CHRYSLER A604 (41TE) UPDATE HANDBOOK

INDEX

*Updated
May, 2003*

Figure 61

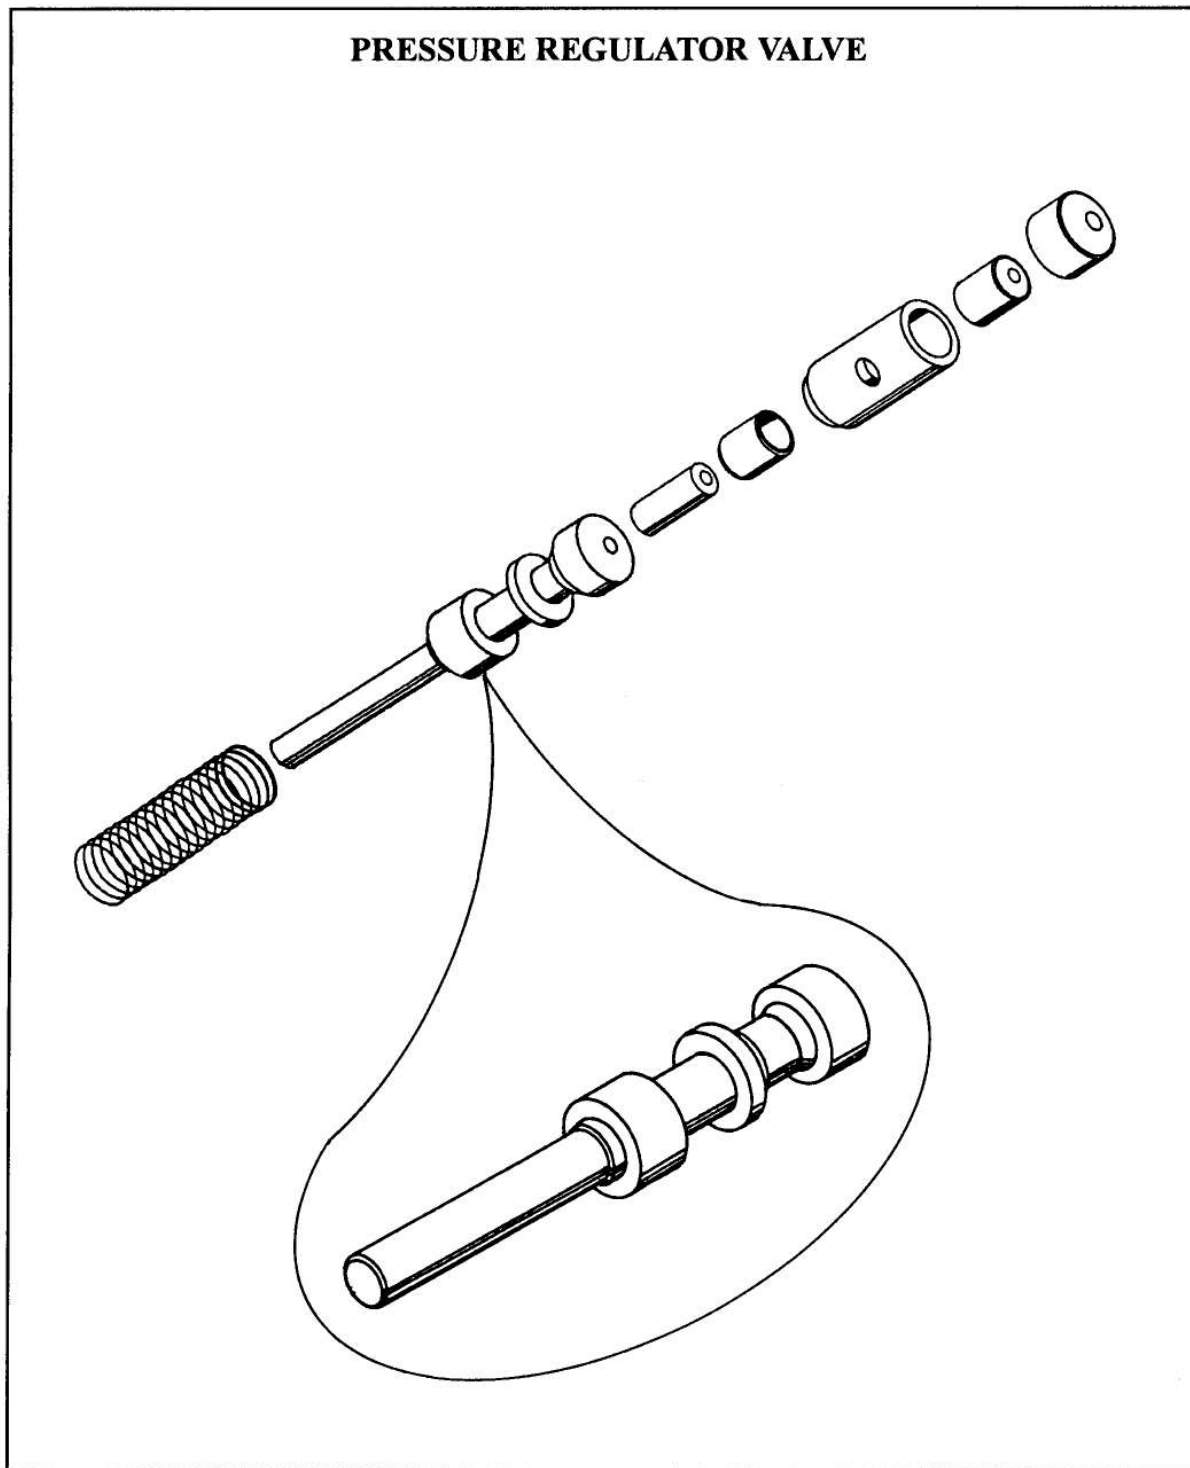
CHANGE : A running change in 1994 was made to the spacer plate (See Figure 60) and to the Pressure Regulator Valve (See Figure 61).

Figure 62

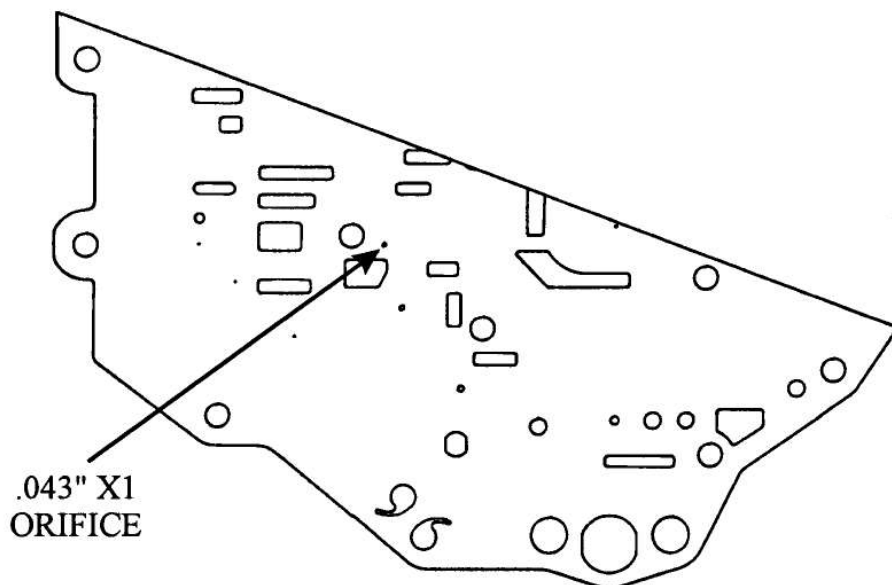
- (1) : **SPACER PLATE:** The "X1 Orifice" in the spacer plate has been eliminated as shown in figure 62. The plate can be easily identified by the number "82" that is punched through the plate (See Figure 62).
- (2) : **PRESSURE REGULATOR VALVE:** A ground step has been machined to the inner land on the Pressure Regulator Valve causing two different diameters to exist on one land (See Figure 63). There are no obvious or visible signs or identification marks to indicate the updated Pressure Regulator Valve. Careful measurement of the valve land is needed to properly identify the valve (See Figure 63). The spring side of the land measures approximately .6255". The opposite end of the same land will measure approximately .6245" (See Figure 63).

Figure 65

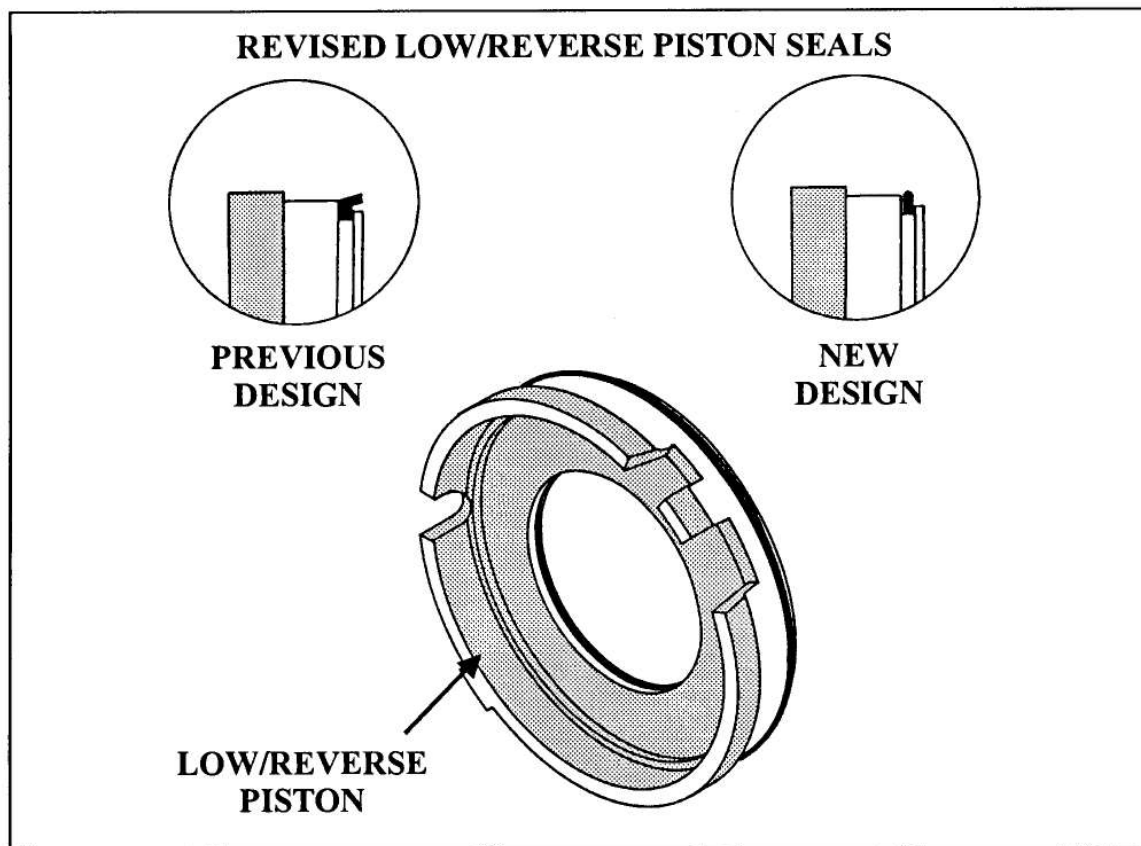
CHANGE: Beginning at the start of production for 1995 model year, all Chrysler A604 (41TE) and A606 (42LE) transaxles were produced using revised seals for the Low/Reverse piston. The previous "Lip" type seals have been replaced by a "D" Ring type seal for both inner and outer seals, as shown in Figure 65.

- (1) **LOW/REVERSE PISTON SEALS** - Both the inner and outer lip seals have been replaced by a "D" Ring type seal, as shown in Figure 65. There were no dimensional changes necessary to the Low/Reverse piston to accommodate the new "D" Ring seals. The seals are available under OEM part number 4659185 for the outer seal, and 4659184 for the inner seal.

Low/Reverse Piston Outer Seal ("D" Ring)	4659185
Low/Reverse Piston Inner Seal ("D" Ring)	4659184

Figure 66

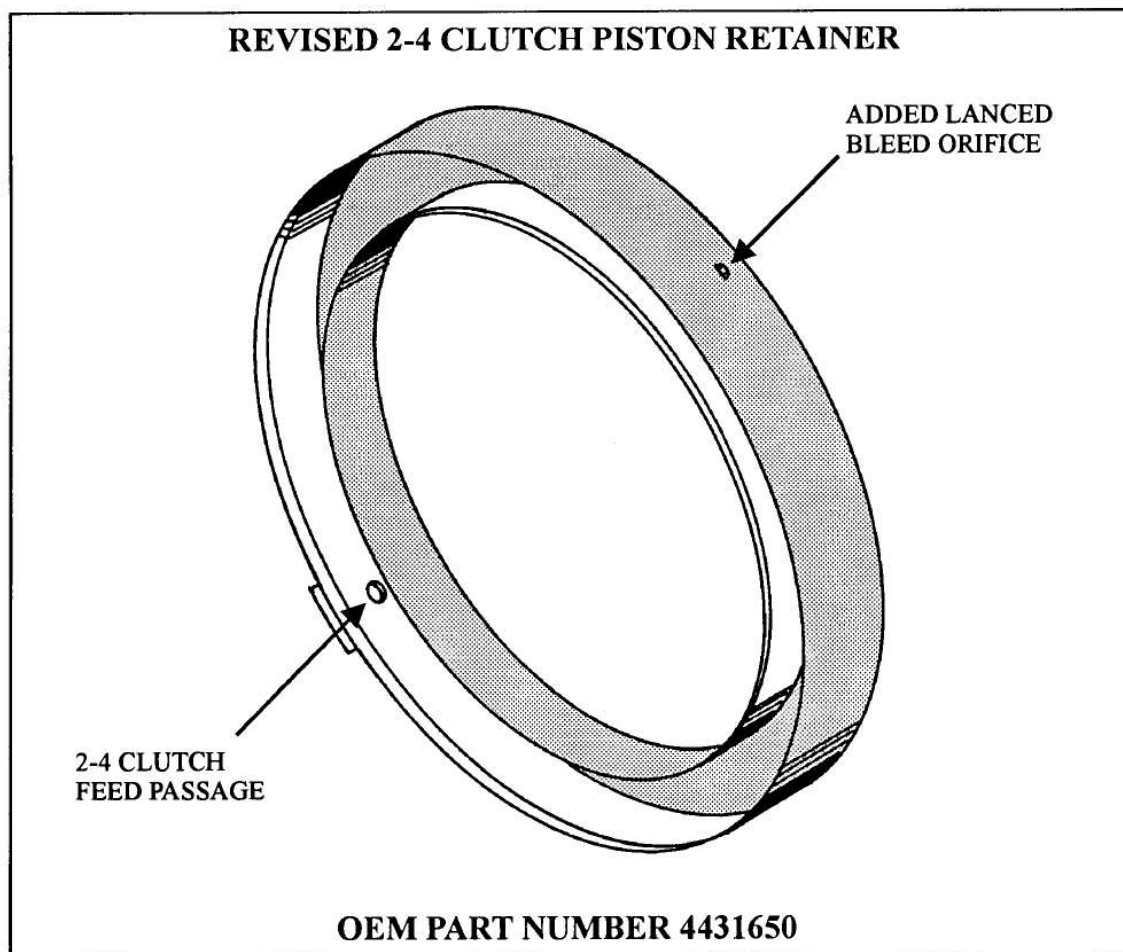
CHANGE: Beginning at the start of production for the 1995 model year, all Chrysler A604 (41TE) and A606 (42LE) transaxles were produced using a revised 2-4 Clutch Piston Retainer with an added lanced bleed orifice (See Figure 66).

- (1) 2-4 CLUTCH PISTON RETAINER - Lanced bleed orifice added to the retainer in the location shown in Figure 66.

The revised 2-4 Clutch Piston Retainer with the added lanced bleed orifice will back service ALL previous models of Chrysler A606 (41TE) and A606 (42LE) transaxles. There was not a part number change, so the revised retainer is available under OEM part number 4431650.

Figure 73

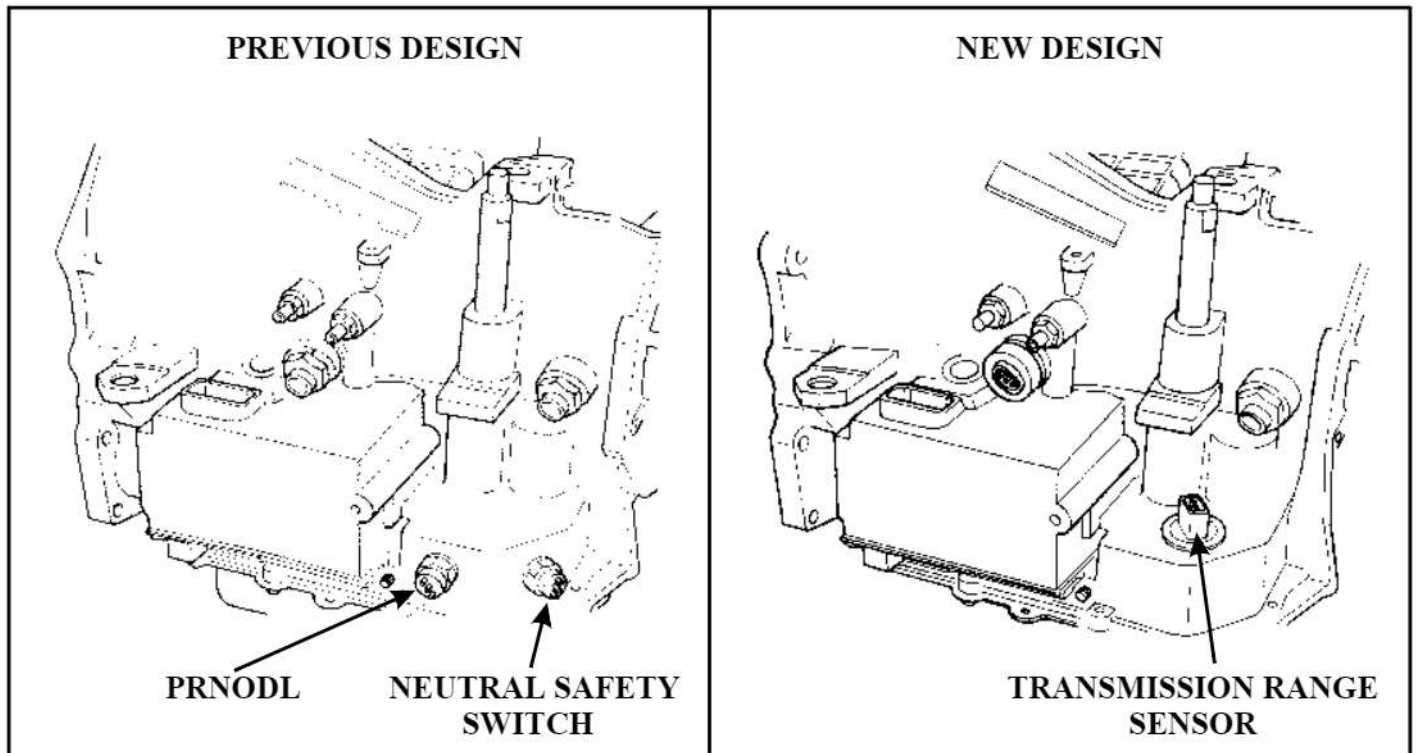
CHANGE: Beginning at the start of production 1996, some models equipped with the 41TE (A604) transaxle replaced the PRNODL and Neutral Safety Switch with a Transmission Range Sensor as seen in Figure 73.

- (1) PRNODL SWITCH - The previously used Park, Reverse, Neutral, Overdrive, Drive, Low Switch (PRNODL) has been eliminated and replaced with the new Transmission Range Sensor (See Figure 73).

- (2) NEUTRAL SWITCH - The previously used Neutral Switch has been eliminated and replaced with the new Transmission Range Sensor (See Figure 73).
- (3) TRANSAXLE CASE - The casting of the case change with the elimination of the two threaded holes for the PRNODL and Neutral Safety Switch. An access hole has been added to accommodate the new TRS sensor connector as the switch which is mounted on the valve body (See Figure 73).
